ARCOM # A-24-0072

Siegfried Residence
127 El Bravo Way
Palm Beach, FL

Previously Approved Hardscape Plan

Proposed Hardscape Plan

2
H2
PROPOSED OVERALL LANDSCAPE
OPEN SPACE DIAGRAM
SCALE: 1/16" = 1' 0"

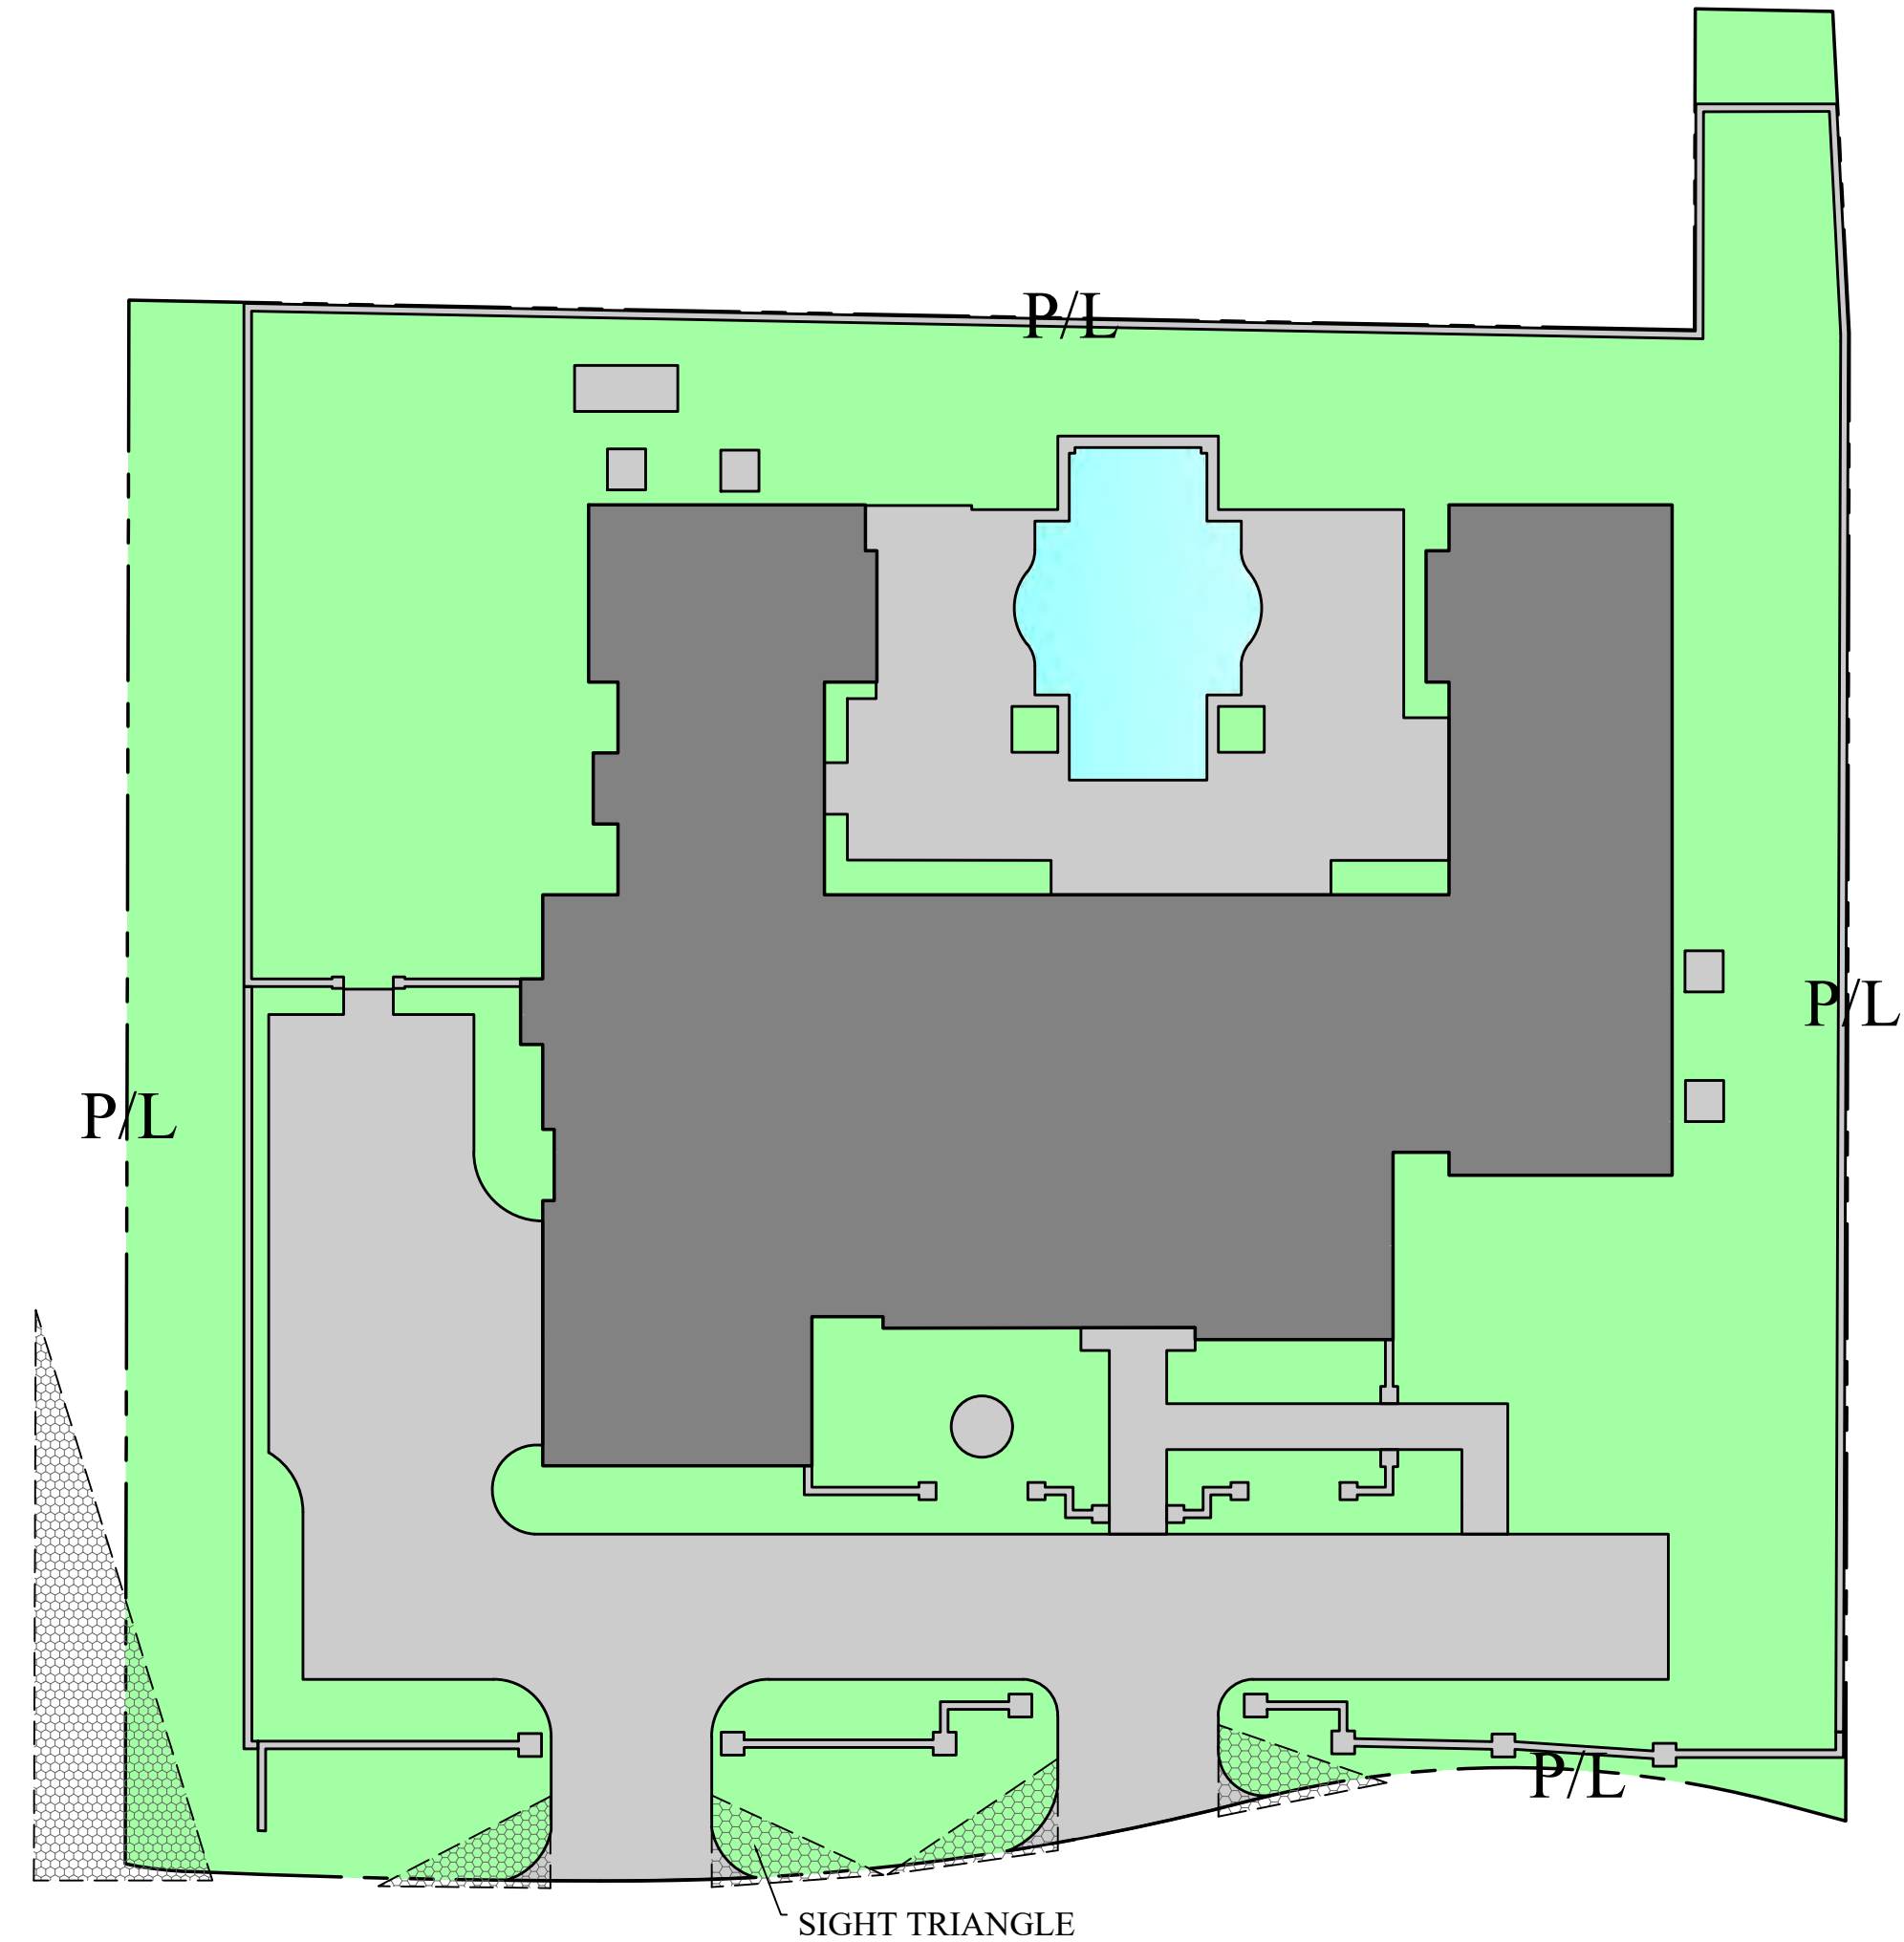
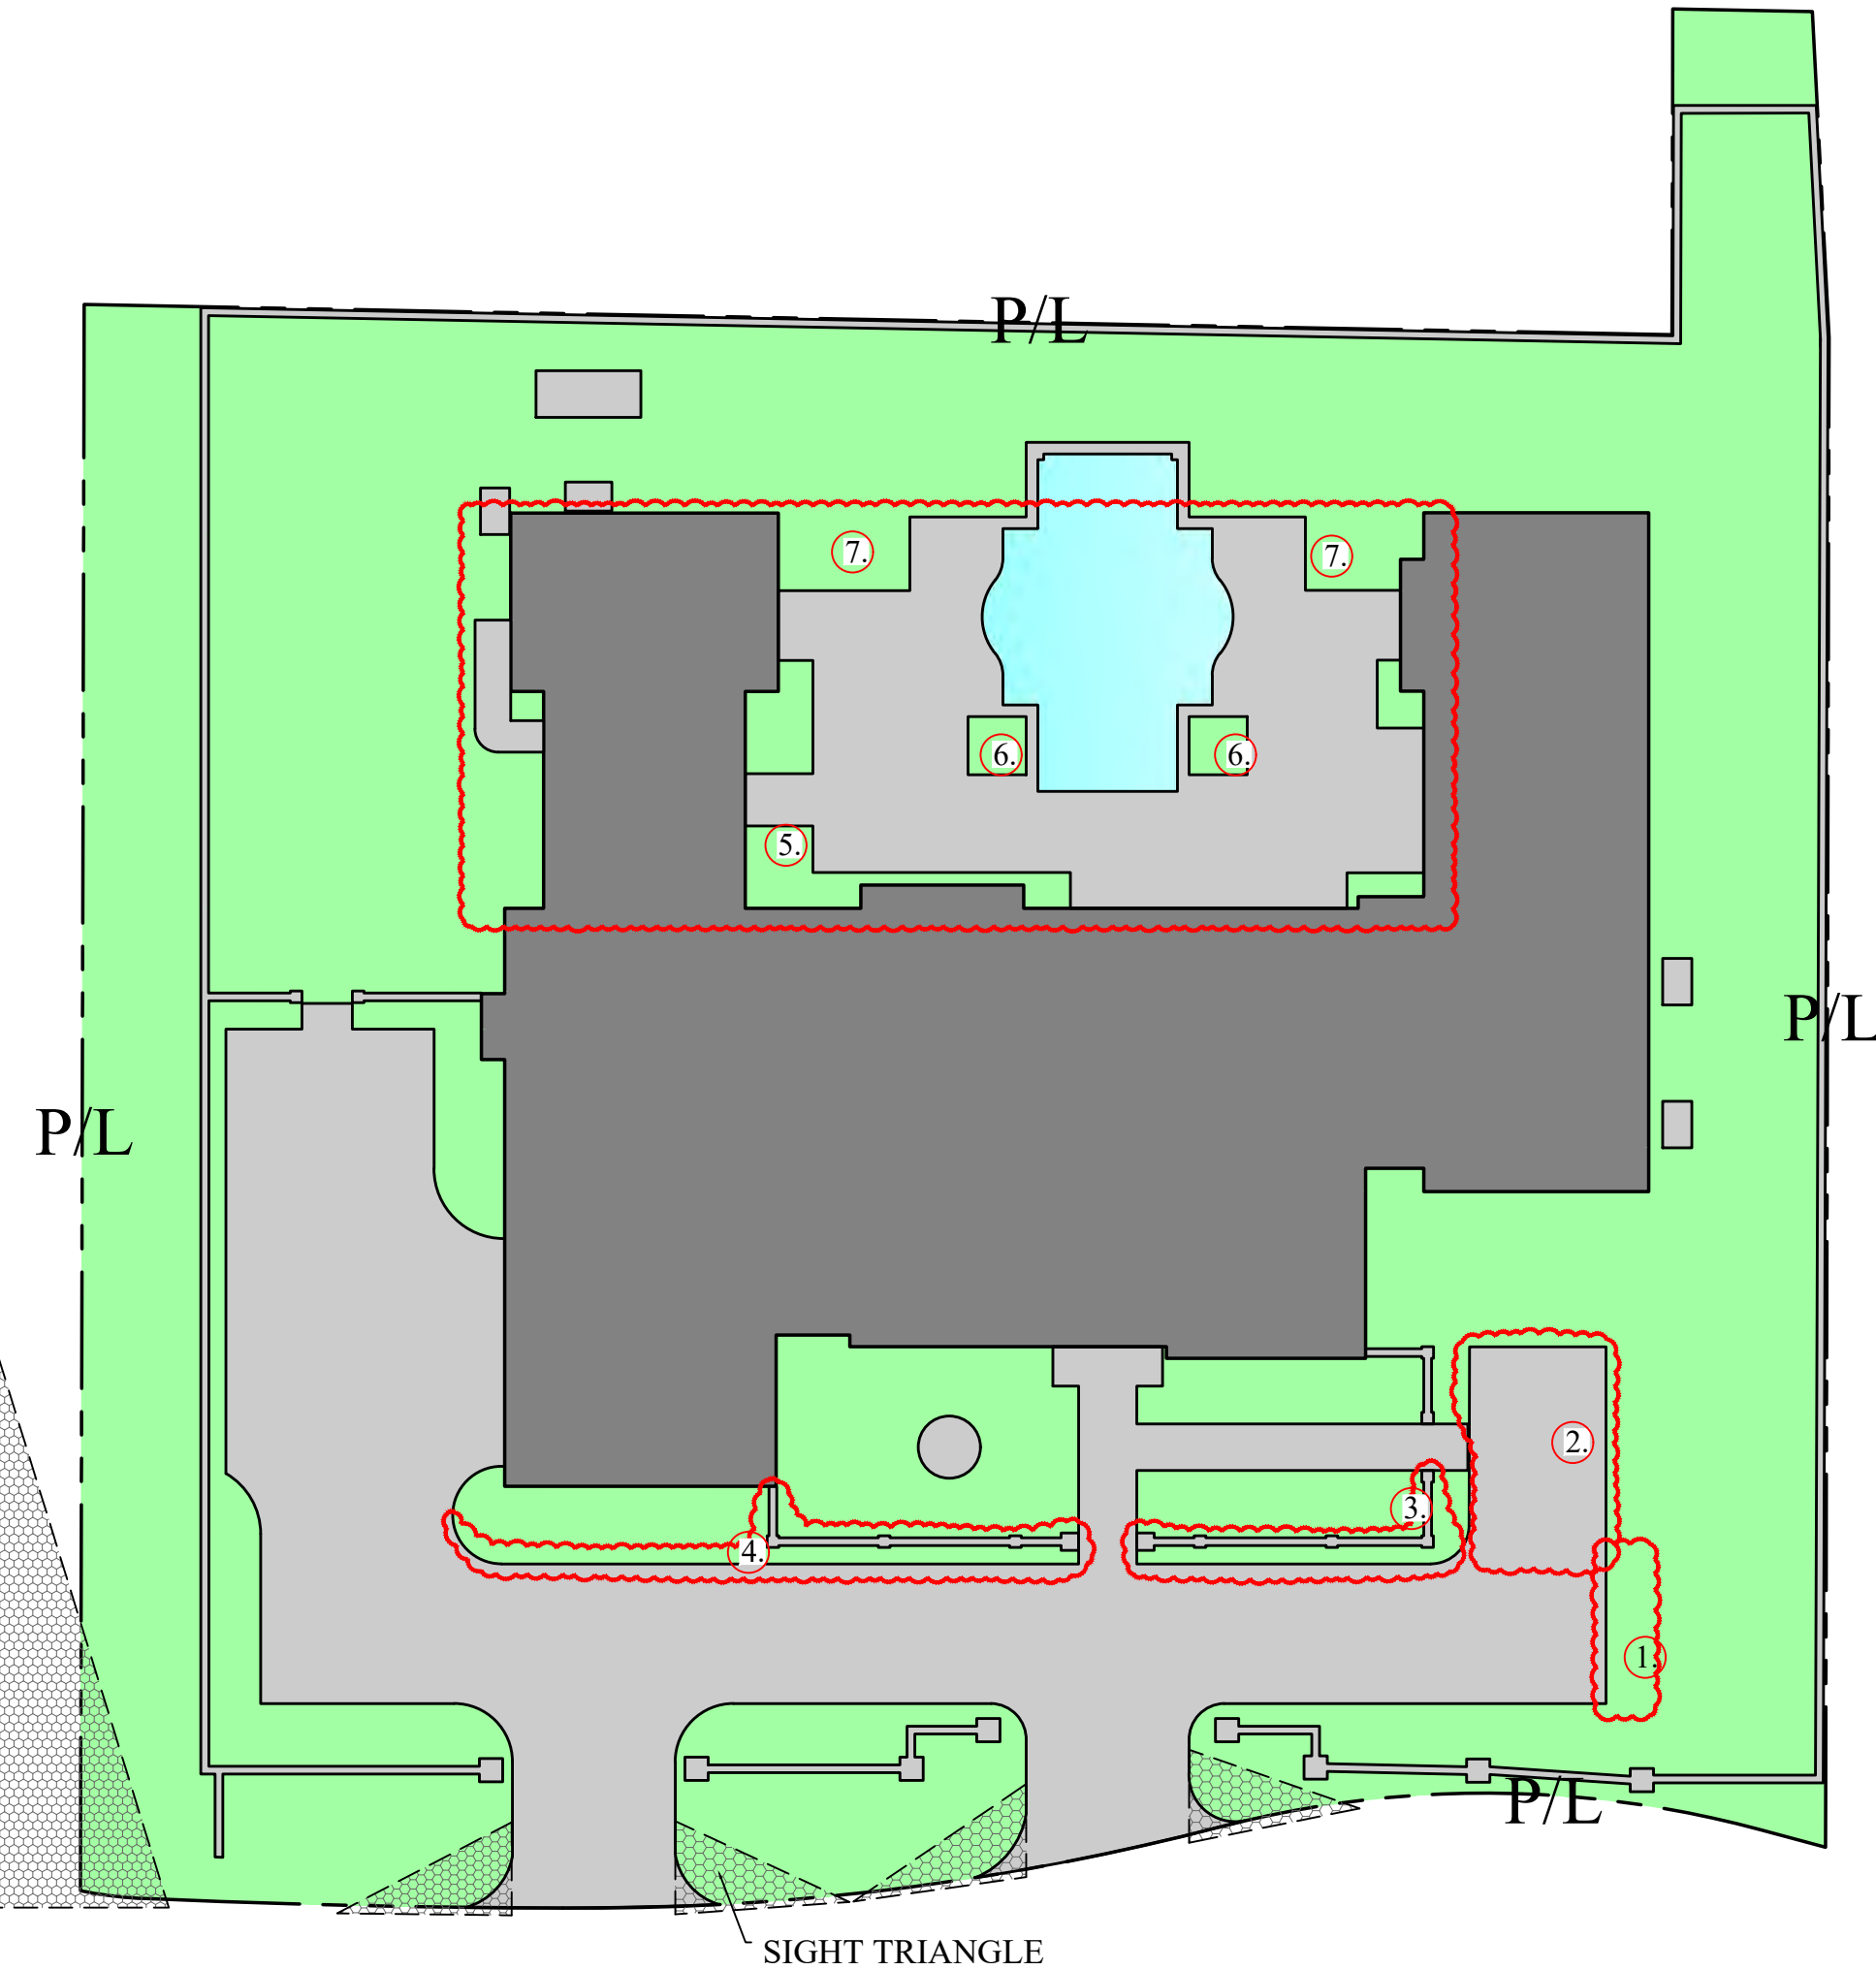
CHANGE LOG NUMBERS FOR THIS SHEET ONLY

1. REDUCE LENGTH OF DRIVE 3' 5"
2. ADD SMALL PARKING SPACE
3. MOVE GARDEN WALL & GATES
4. NARROW DRIVE 9"
5. EXTEND WALK TO LOGGIA
6. ENLARGE PLANTING PITS
7. REDUCE POOL TERRACE
